PROCESS CHANGE NOTIFICATION

PCN1807

Alternate Assembly Sites for Selected Enpirion® Power SoC Devices in QFN Modules with Metal Lids

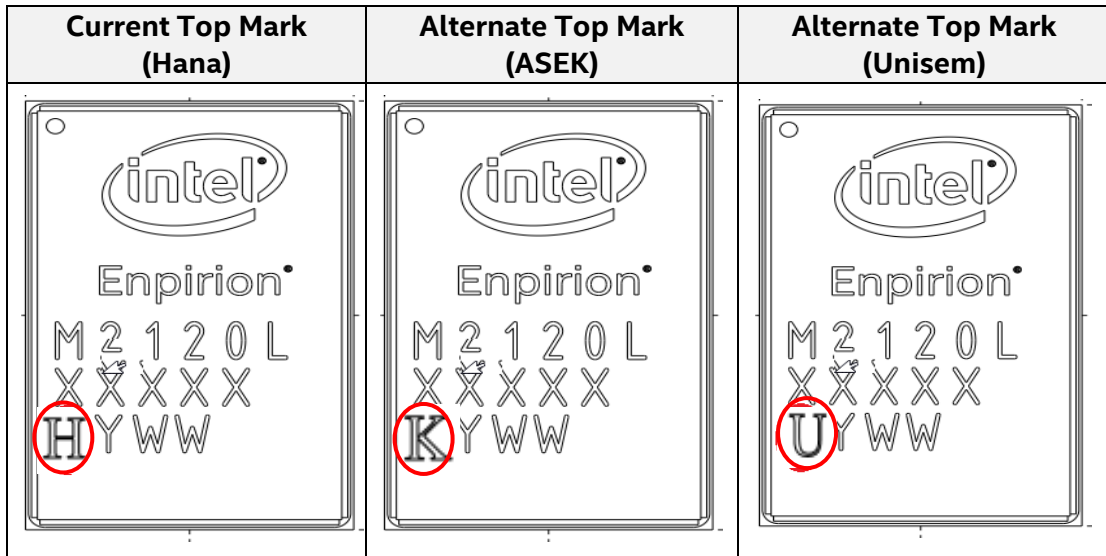
Method to Identify Change Product:

The assembly site of a device can be identified by the lettering on the bottom left hand corner of the top mark.
